Comments on NIST NCSTAR 1 Draft

July 27, 2005

James Quintiere, Prof
Fire Protection Engineering
University of Maryland
College Park, MD 20742
jimq@umd.edu

General Comments

Figure 1. UL and Isolatek results.

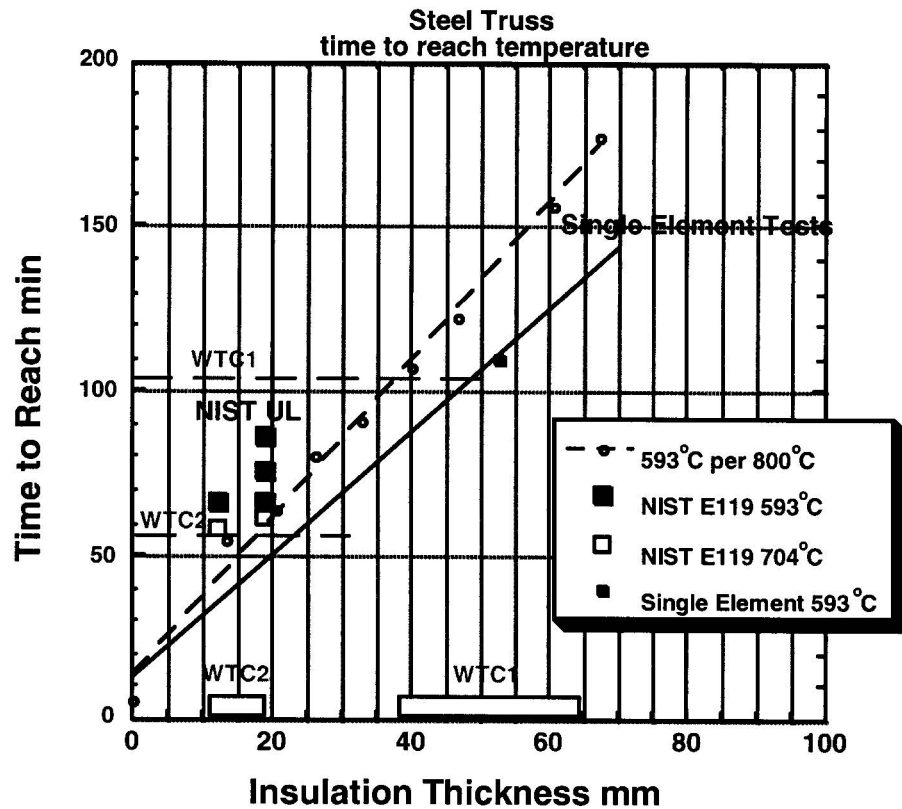
It is noted that the predicted times to reach the critical failure temperature of the truss steel of 55-73 minutes for WTC 2 and 111 minutes for WTC 1 in Table 1 is consistent with the building collapse times of 56 and 102 minutes, respectively. These predicted heating times are also consistent with the NIST measured heating times (to 66 to 86 minutes, although the reduced scale 17 ft span tests compromised heat transfer) in the UL furnace tests at fire temperatures comparable to 800 °C shown in Table 2 taken from NIST. Indeed, the UL time to reach 1100 °F (593 °C) for the 35 ft span ranges from 66 to 116 minutes which is consistent with 73 minutes in Table 1 and an extrapolated time of 50 minutes for the UL temperature conditions. (See Figure 1.)

Consequently, if the truss elements with specified insulation levels of ½- ¾ in. for WTC 2 and 1 ½ in. for WTC 1 can be heated to about 600 °C in an 800 °C fire at computed times of 55-73 minutes and 111 minutes, respectively, and NIST and others determined that the truss would cause either column buckling or connection failure at 600 °C or below, then this mode of collapse cannot be discounted. This is especially compelling since the collapse times are consistent at 56 and 102 minutes. Moreover, it is commonly known that floor sections were collapsing up to 20 minutes before the full collapse of each of the buildings. NIST has not addressed those early failures.

Figure 2. Predicted upper layer temperatures at various locations on the 97th Floor.

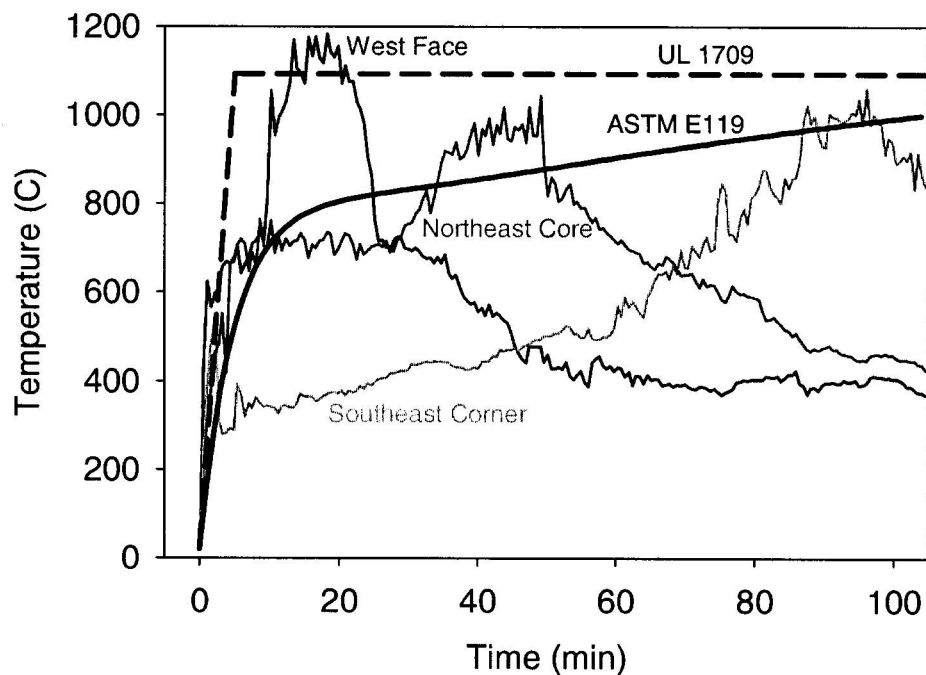
The results of the NIST fire predictions are based on a fuel loading of 4-5 psf. These levels are based on data from the impacted floors of Marsh & McLennan in WTC 1. NIST says this has “high” accuracy [p 119]. They find for WTC 1 that a given floor did not have uniform temperatures. “At any given location, the duration of temperatures near 1,000 °C was about 15 min to 20 min.” [p 127] Upper layer temperatures are shown in Figure 2 for WTC 1 97th floor [NIST]. Temperatures generally exceeded 600°C for about 30 minutes, and for about 60 minutes in the core. In contrast, a scale model test conducted at the University of Maryland, representative of the 96th floor with a simulated fuel load of 11.5 psf, shown in Figure 3 indicates temperatures are generally over 600°C for 100 minutes, but are much cooler in the core. These results are distinctly different from the NIST simulation. One may be dubious of scale modeling, but it is a tried and true technique.

Figure 3. Temperatures in a scale model of WTC 1 96th floor

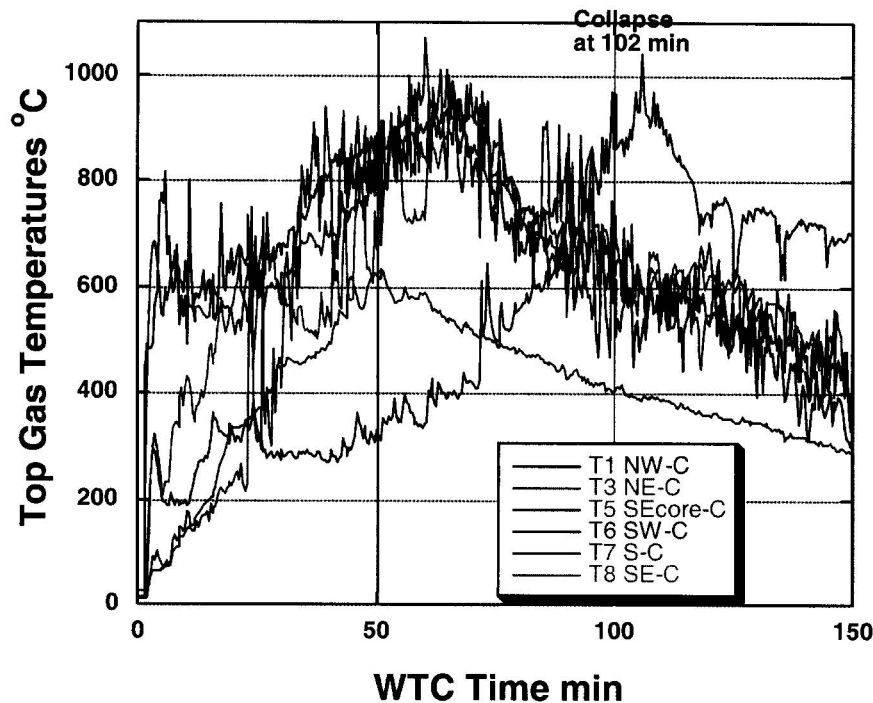
The heavier fuel load in the scale model was based on traditional office loadings and on anecdotal interviews of people familiar with the floors. Subsequently, we conducted a fuel load survey of the 96th floor based on architectural plans obtained from the furniture installer. This led to a conclusion that a loading of 10 psf or greater was the case. Appendix C contains the details in a report. Figure 4 shows a section of the architectural plans used for the 96th floor. A handwritten notation indicates a section of common files that ringed the core of the office space. There were 170 of these 4-drawer lateral files. NIST completely ignored this fuel load (and others) in their assessment. We assigned 100 lbs of paper per draw (a sub-capacity level) giving 68,000 lbs for this contribution. In addition, there were other common files and a storage room that gave a grand total of 95,400 lbs not included by NIST. In the survey conducted by Kate Stewart, estimates of paper and personal items were included in the workstation loads based on typical office conditions. Our total floor combustible loading was estimated at 302,062 lbs

compared to 134,640 lbs determined by NIST. Taken over the office floor space area (31,013 ft²), this computes to 9.7 psf and 4.3 psf for NIST. Our paper extimat per file draw is well below

Figure 4. Section of furniture layout WTC 1 96th floor

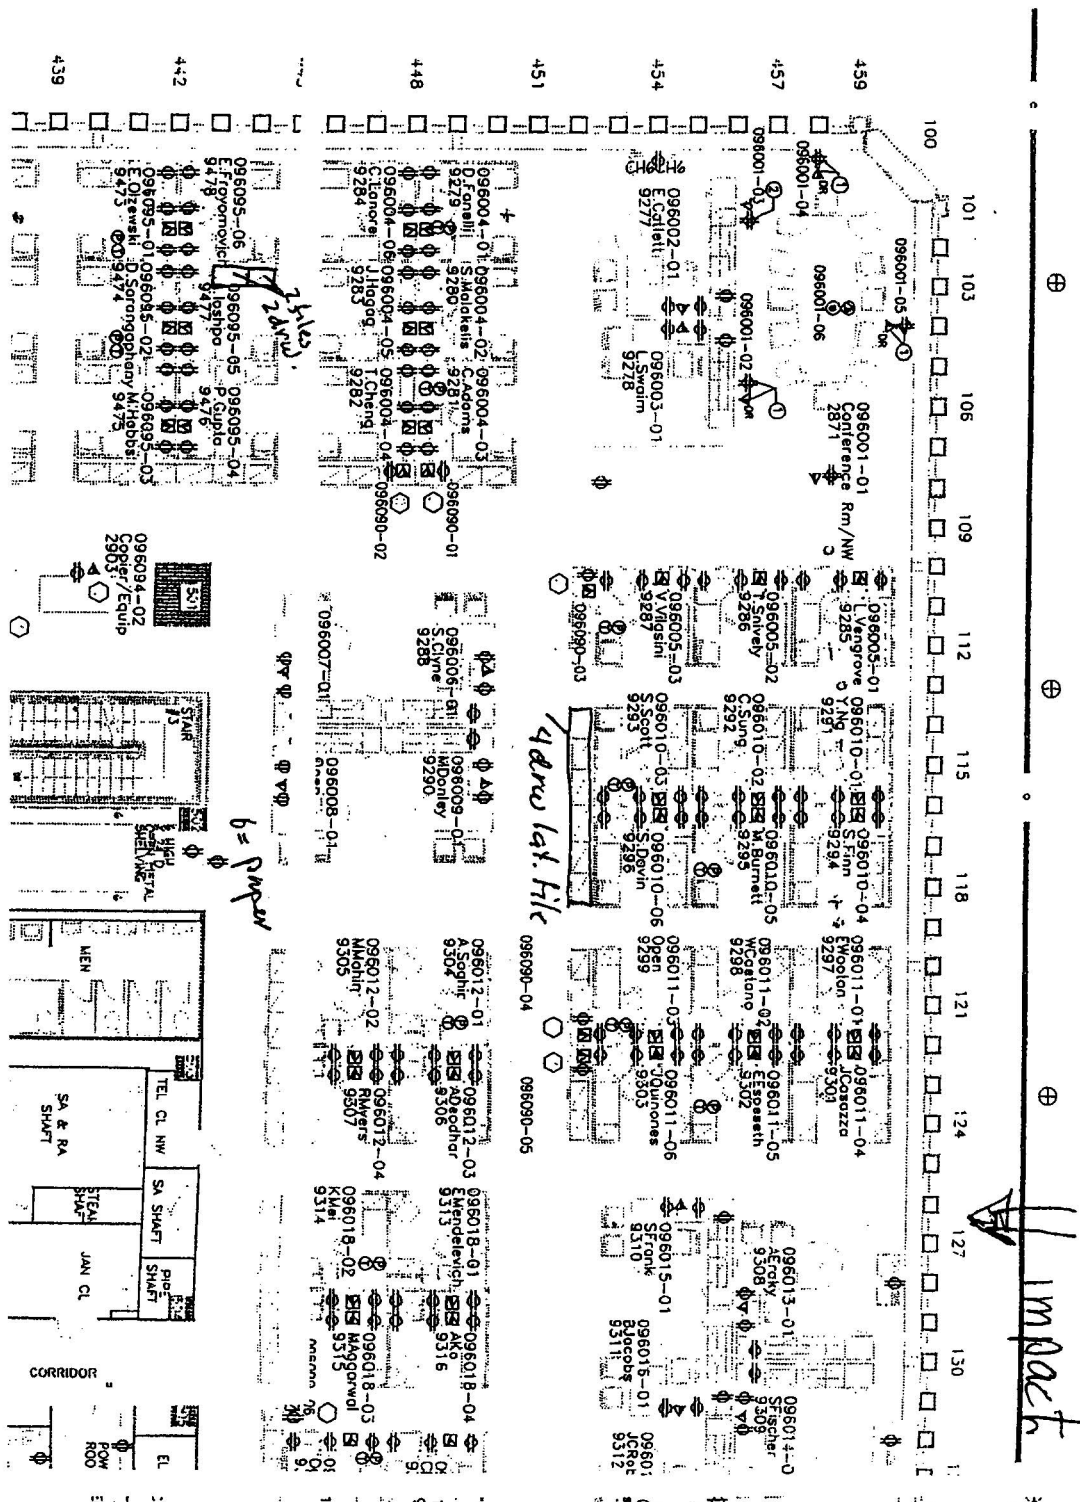
capacity, so the loading we determine is likely too low. Indeed, it was told to us that Marsh was a “paper hog” and “kept everything”. Paper fuel in closed files is de-rated in fire design considerations, but the aircraft impact could have opened the file draws.

Figure 1. UMCP estimate of how the total workstation weight is distributed.

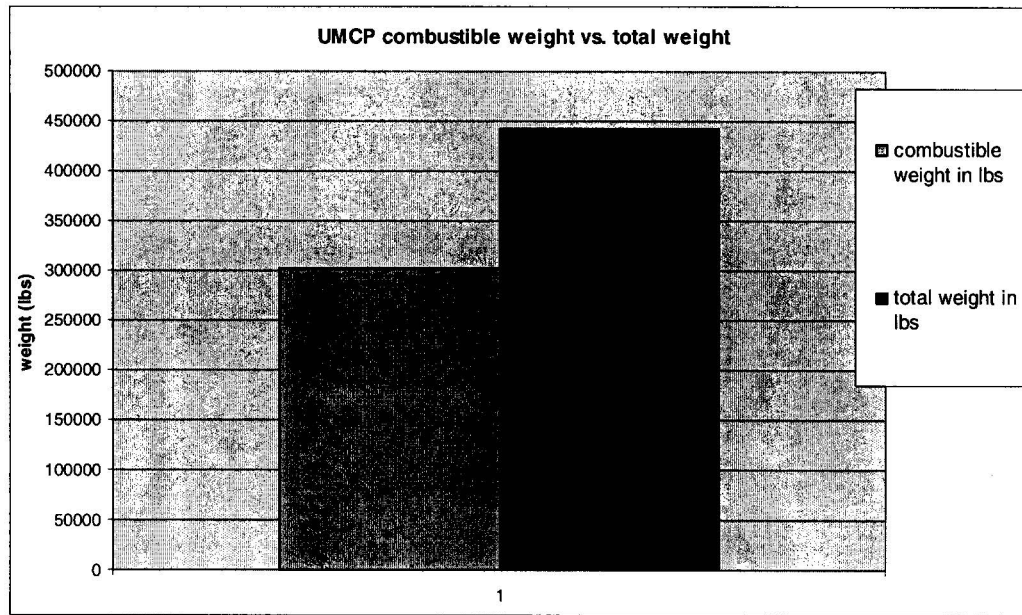
- ❑ The cabinets used by NIST contained two reams of packed paper, which is not consistent with the files that I weighed. The significance is that the tighter the packed paper is, the less air can get in to feed the fire whereas, typical files are not uniform in size or spacing and leave room for air to supply the fire.
- ❑ The following are graphical representations of the difference between the paper weight not included (NIST) and the total weight inclusion (UMCP):
